Report No: D0411 Item 8

Subject: 117 RAILWAY ROAD, SYDENHAM

Action: Recommendation

Prepared By: Kim Linden - Development Assessment Officer (Planning)

Image 1: Existing site layout

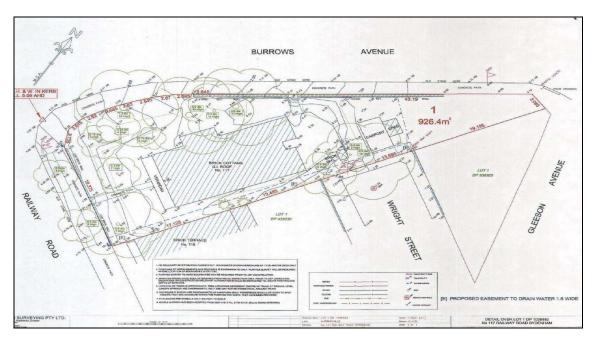
While testing was undertaken directly adjacent to the cottage, the RAP did not investigate soils beneath the structures to be demolished including the soil beneath the cottage. It is considered that testing under the cottage should have been undertaken in this instance so as to confirm the extent of contamination under the dwelling. The proposal therefore fails to demonstrate that category 1 remediation under the dwelling is required.

It is therefore considered that the application fails to demonstrate that there are contaminants in the soil under the cottage and that the cottage has contamination that could not be addressed through refurbishment. In the absence of testing for contaminants under the dwelling there is not considered to be adequate evidence to support a case for demolishing the dwelling to allow for Category 1 remediation of soils under the dwelling.

Image 2: Proposed trees to be removed shown in dashed outline.

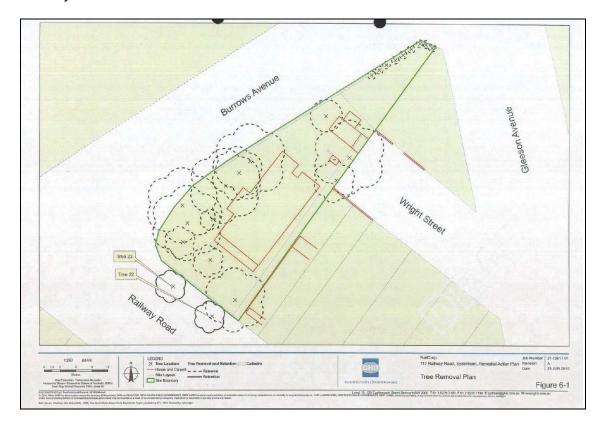
Clause 56 of MLEP 2001 concerns the protection of trees under Council's Tree Preservation Order. The site contains a large number of trees, including very mature trees, and shrubs which are highly visible from the public domain. The proposal seeks removal of 21 trees from the site. An Arboricultural Implication Study, prepared by GHD for Railcorp and dated June 2010, was submitted with the application. Table 6-1 and Figure 6-1 of the study detail the trees to be removed and those to be retained.

Section 5.0 (Tree Impacts) of the Arboricultural Implications Study (AIS) states that the 21 trees are to be removed because of the adverse tree impacts that the proposed remediation will have on the trees on site. The proposed remediation includes removal of 800mm depth of topsoil containing contaminated material. According to the study this will have the likely effect of "exposing primary roots which may reduce moisture to the root zone; permanently destroying primary, secondary and tertiary roots within the Structural Root Zone (SRZ) and the potential for inflicting wounds to primary and secondary tree branches by mechanical means." The study also states at section 5.2 that the demolition of the house will have direct impacts on the SRZ and Tree Protection Zones of Trees 1, 3, 5, 6, 8, 10 and 11.

Two (2) street trees (labelled Tree 22 and tree 23 on Figure 6-1 of the study) located adjacent to the site on the Council nature strip are to be retained.

(xiv) Two trees indicated as being removed are street trees.

The application was referred to Council's Tree Management Officer who has agreed to the removal of the trees covered by Councils Tree Preservation Order (TPO). Those are trees identified in the study as: Tree1 – *Jacaranda mimosifolia* (Jacaranda), Tree 3 – *Cinnamonum camphora* (Camphor Laurel), Tree 5 – *Lophostemon confertus* (Brush box), Tree 6-Harphephyllum caffrum (Kaffir Plum), Tree 7 – *Ficus elastica* (Rubber tree), Tree 10 –

Platanus x hyspicanica (Plane Tree), Tree 11 – Jacaranda mimosifolia (Jacaranda). Council's Tree Management Officer has agreed to the removal of those trees subject to the imposition of appropriate conditions.

All other trees (Trees 2, 4, 8, 9, 12-21) are exempt from Council's Tree Preservation Order due to their dimensions or species and can therefore be removed without approval.

The street trees shown on the plan are to be retained.
